22-COA-0173

927 E. Main Street

Butchertown Architectural Review Committee

May 31, 2023

West Elevation May 18, 2023

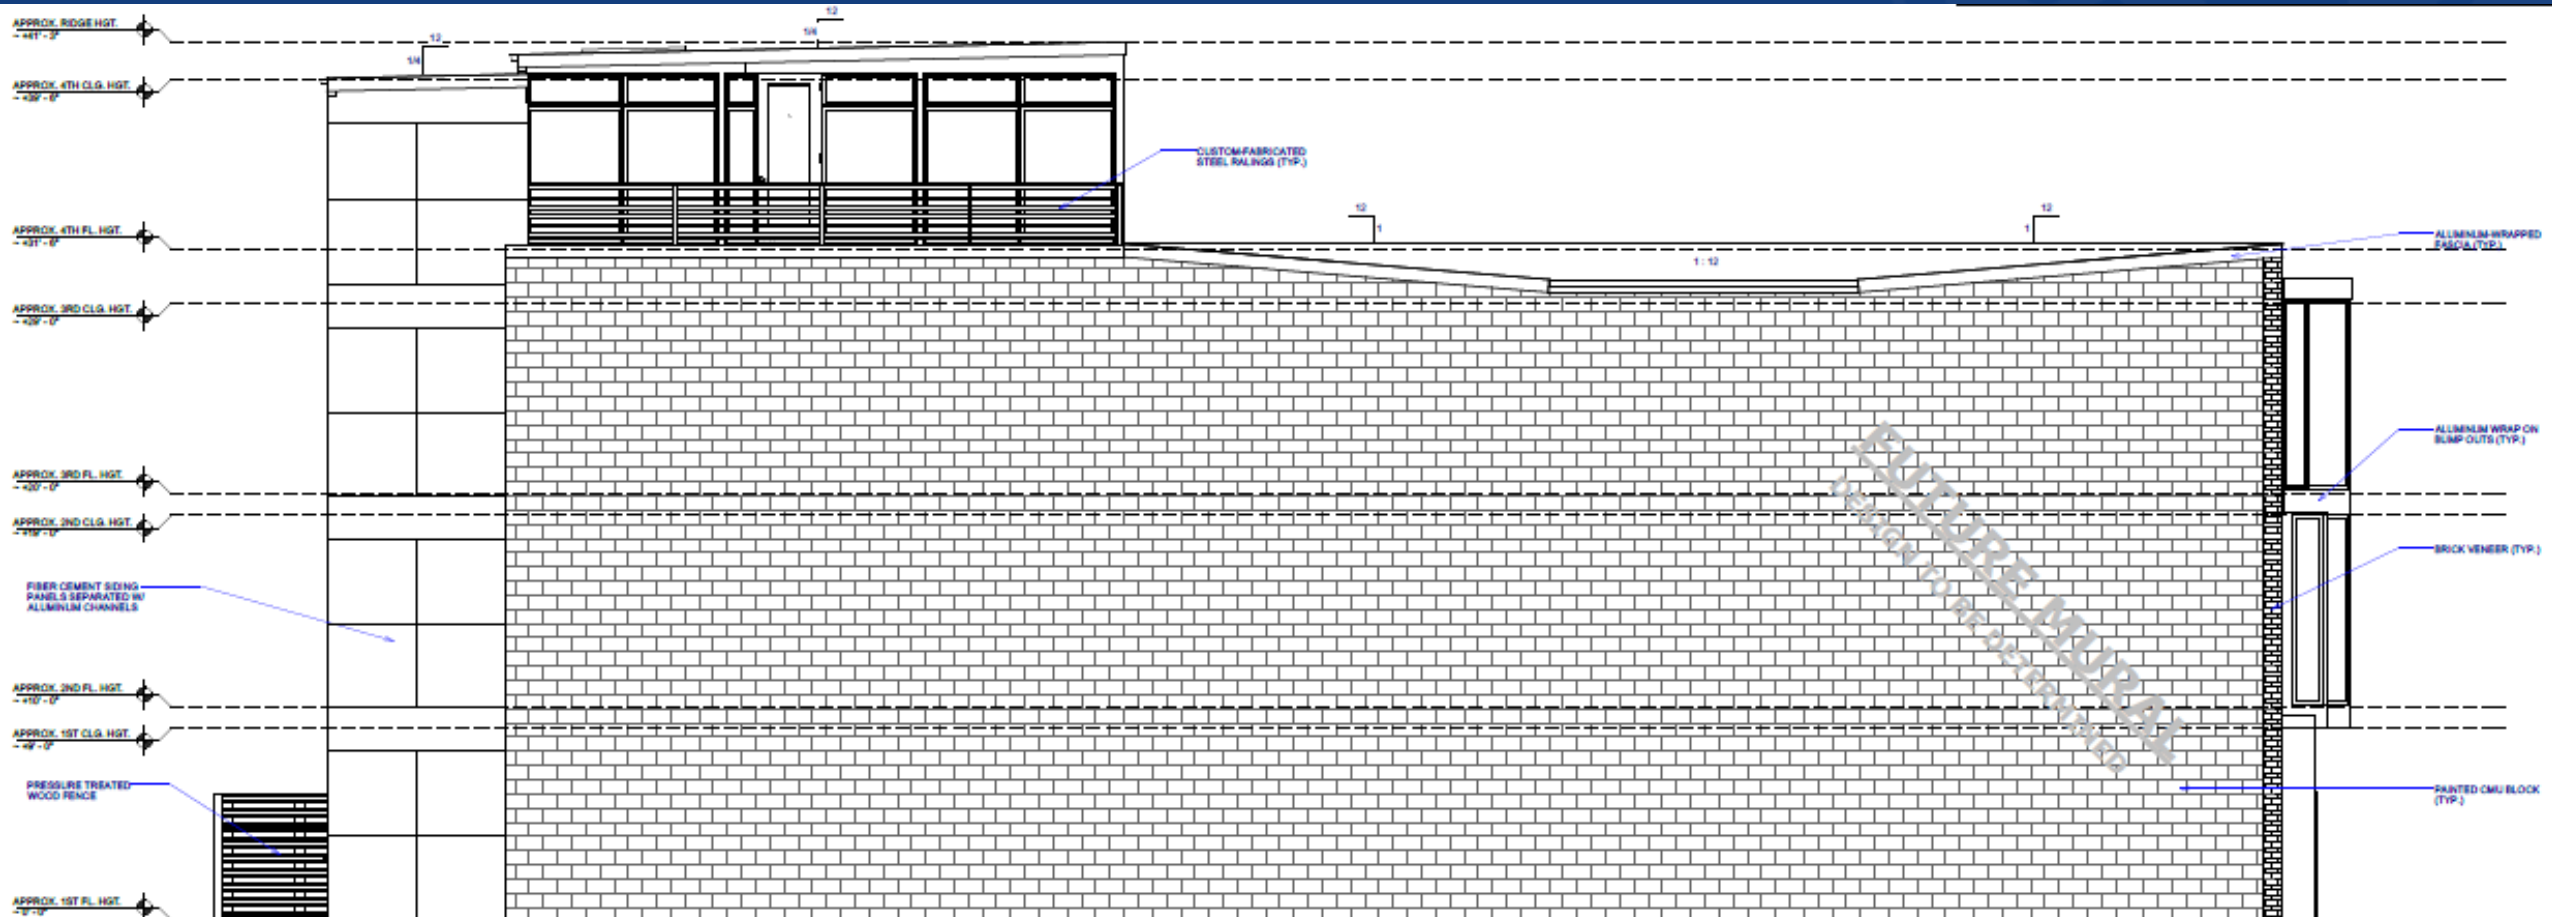
1. The west elevation CMU wall shall be covered with a mural approved by Landmarks staff. The proposed mural should also be reviewed by Metro's Commission on Public Art (COPA).
2. The third story picture windows shall be reduced to a scale similar to the first and second story windows.
3. All window glazing shall be clear.
4. The fiber cement panels on the rear elevation shall be treated in a way that breaks up the massing. That can be further architectural detail, paint, etc.
